UNITED STATES ENVIRONMENTAL PROTECTION AGENCY  
WASHINGTON, D.C. 20460

November 17, 2021

### **EPA’s Reconsideration of its November 30, 2020 Letter Regarding the Applicability of its 2008 Clean Water Act Section 404(c) Final Determination for the Yazoo Pumps Project to the 2020 Yazoo Pumps Project**

Figure 2. Plate 4-1 from the 2007 FSEIS, Project Location and Vicinity Map.

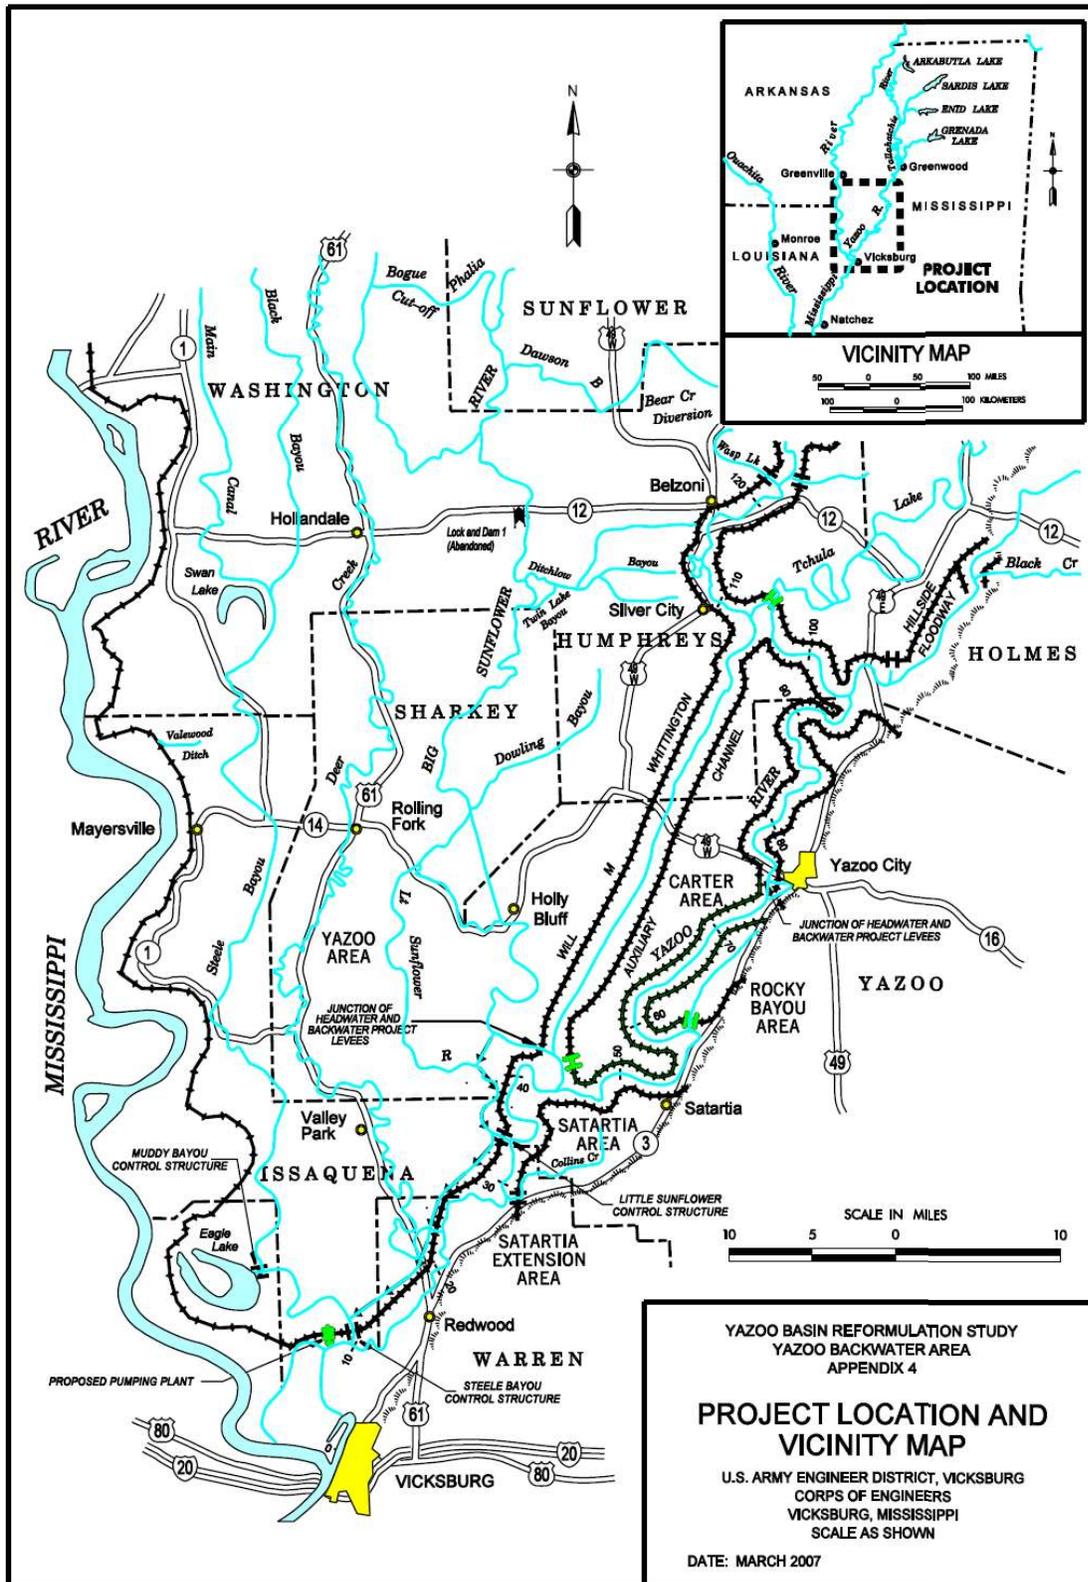
area extends northward about 65 miles to the latitude of Hollandale and Belzoni, Mississippi, and comprises about 1,446 square miles (926,000 acres).” (Main Report, p. 20). Plate 4-1 is found in 2007 FSEIS Appendix 4 (Glossary of Terms and Report Plates) and is reprinted as Figure 2, below.

As noted above, Figure 2 below is a reprint of 2007 FSEIS Plate 4-1, which the Corps identified as the Yazoo Backwater Project Area in the 2007 FSEIS. Figure 3, below, is Plate 4-1 annotated by EPA to identify the proposed locations of the Steele Bayou and Deer Creek pumping stations as well as features identified in the description of the boundary of the Yazoo Backwater Project Area that are relevant for determining whether the Deer Creek pump location is within the boundary of the Yazoo Backwater Project Area. As demonstrated by Figure 3, the proposed Deer Creek pumping station location falls within the triangular shaped Yazoo Backwater Project Area that has an eastern boundary demarcated by the hill line, a western boundary demarcated by the Mainline MS River east bank levee, and a northern boundary demarcated by the latitude of Hollandale and Belzoni, MS.

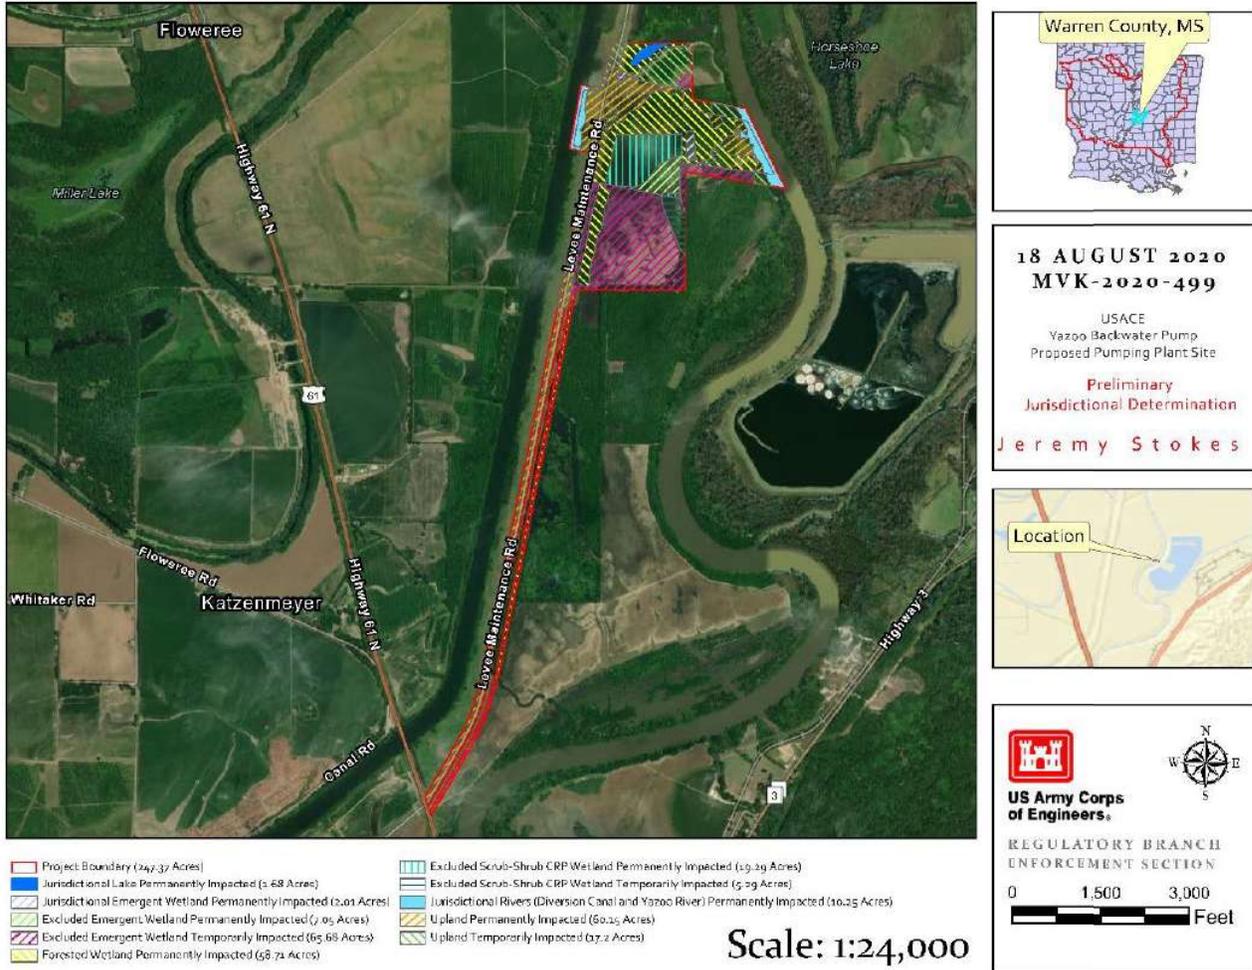
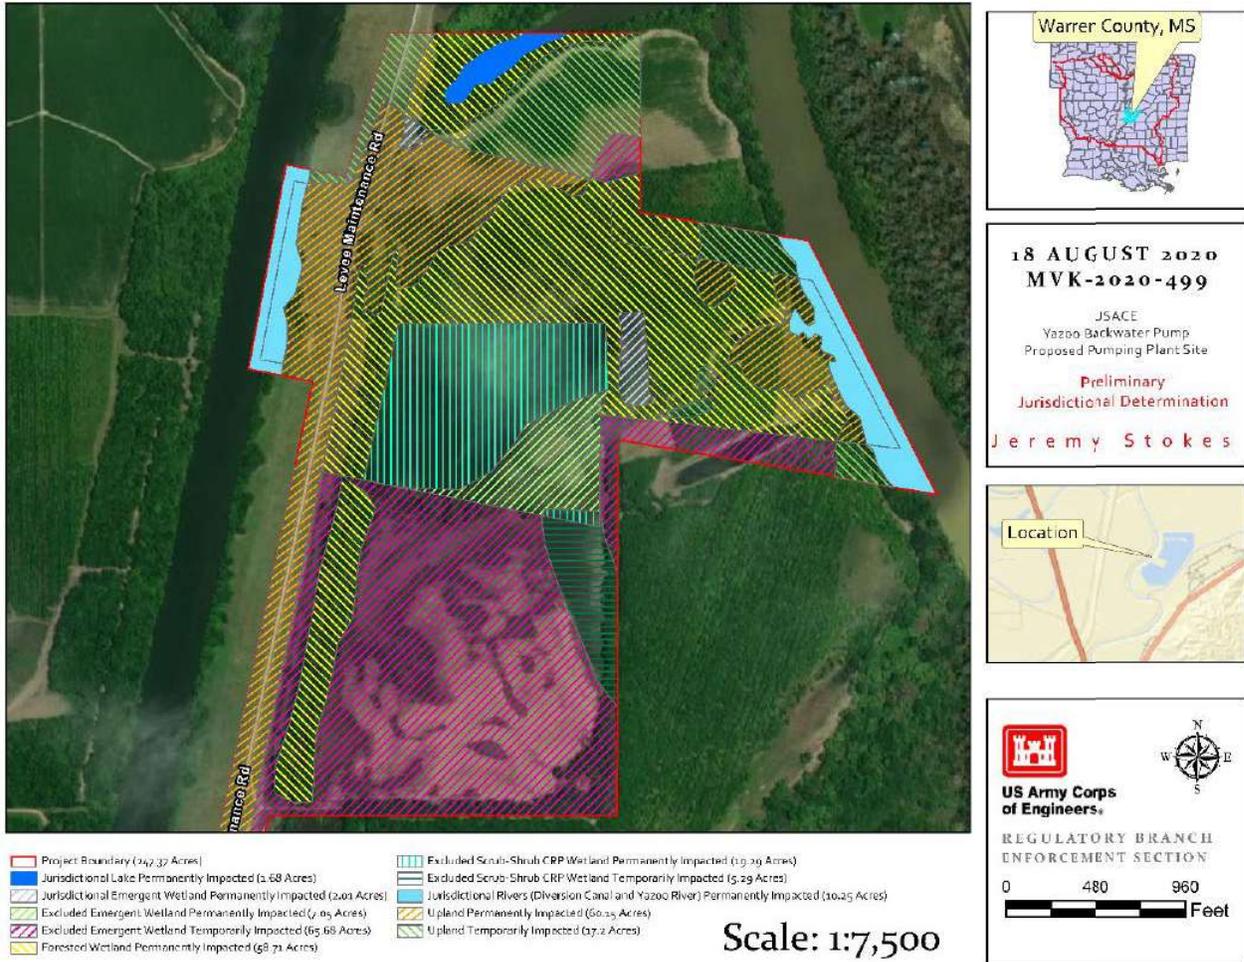
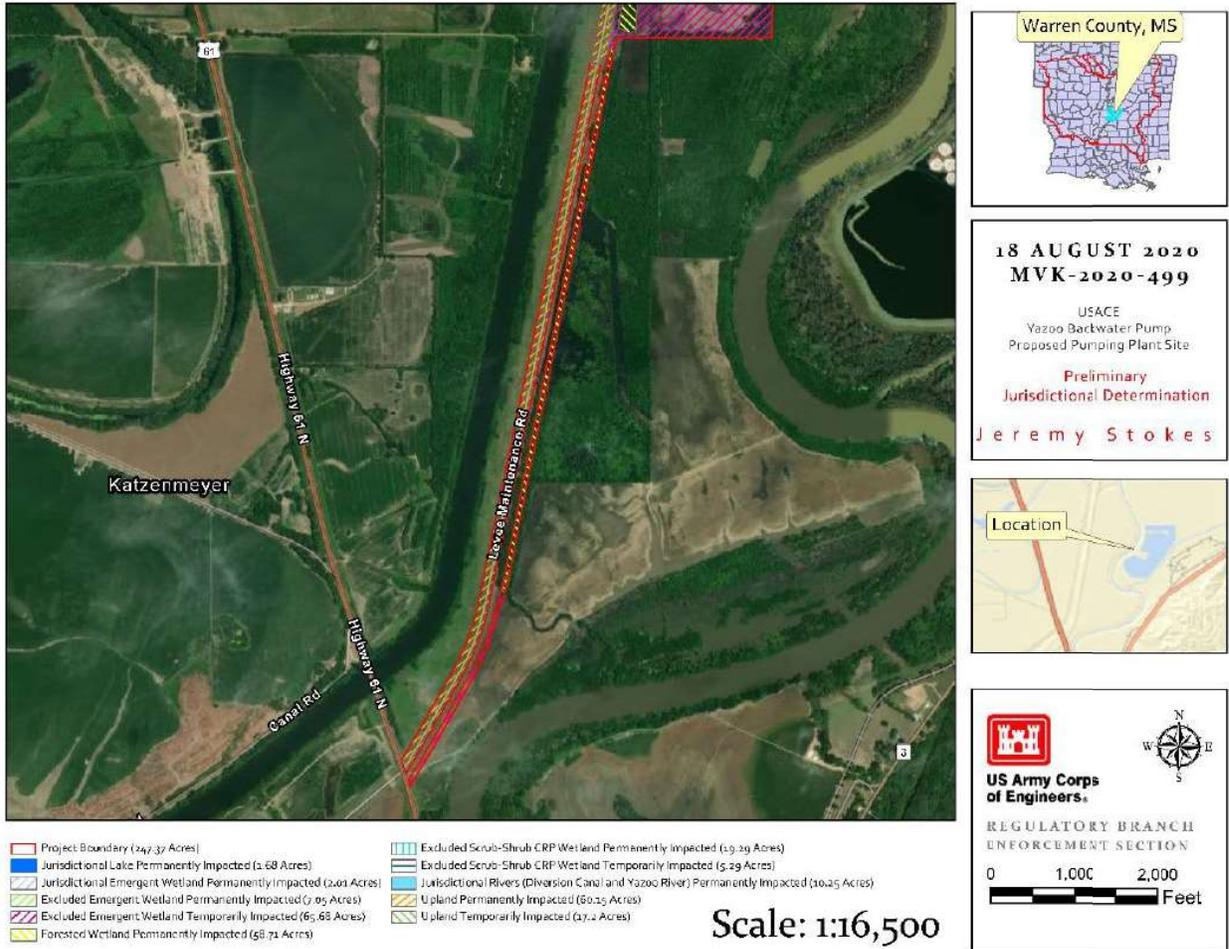
Furthermore, Figures 4a-d, below, which are reprints of Figures 7-10 from Appendix L (CWA Section 404(b)(1) Evaluation) of the 2020 FSEIS provide further confirmation that all the discharges associated with constructing the 2020 Plan fall within the Yazoo Backwater Project Area. Figure 4a shows the proposed Deer Creek pumping station location. The footprint of the pump station is situated between the connecting channel and the Yazoo River, an area that clearly falls within the larger triangular shaped Yazoo Backwater Project Area described above. Figure 4b shows a close-up of the pump station footprint with discharges identified by blue shading in the connecting channel on the west and the Yazoo River on the east. Figure 4c identifies the footprint of the access road to the proposed Deer Creek pumping station location. The access road footprint is also situated between the connecting channel and the Yazoo River, which is also within the larger triangular shaped Yazoo Backwater Project Area. Figure 4d shows the footprint for the proposed borrow area and the proposed access road to the borrow area. These are adjacent to the proposed Steele Bayou pump site location, an area that also clearly falls within the larger triangular shaped Yazoo Backwater Project Area.<sup>23</sup>

<sup>23</sup> The 2007 FSEIS also contains a second description of the Yazoo Backwater Project Area. However, the entirety of the 2020 Plan is within the boundary of this area as well. This second description reads: “The Yazoo Backwater Project Area is bounded on the west by the left descending bank of the mainline Mississippi River levee, on the east by the west bank levees of the Will M. Whittington Auxiliary channel and the connecting channel, and the Yazoo River on the south (926,000 acres).” (2007 FSEIS, p. SEIS-1). Figures 4a-d demonstrate that the entirety of the 2020 Plan is within the area delineated in the second description since the Deer Creek pumping station and access road sites are located north of “the Yazoo River on the south.” (Figures 4a and 4c). As discussed above, the pumping station itself entails discharges into the connecting channel (Figure 4b). The borrow site and borrow site access road are also located north of “the Yazoo River on the south.” (Figure 4d).
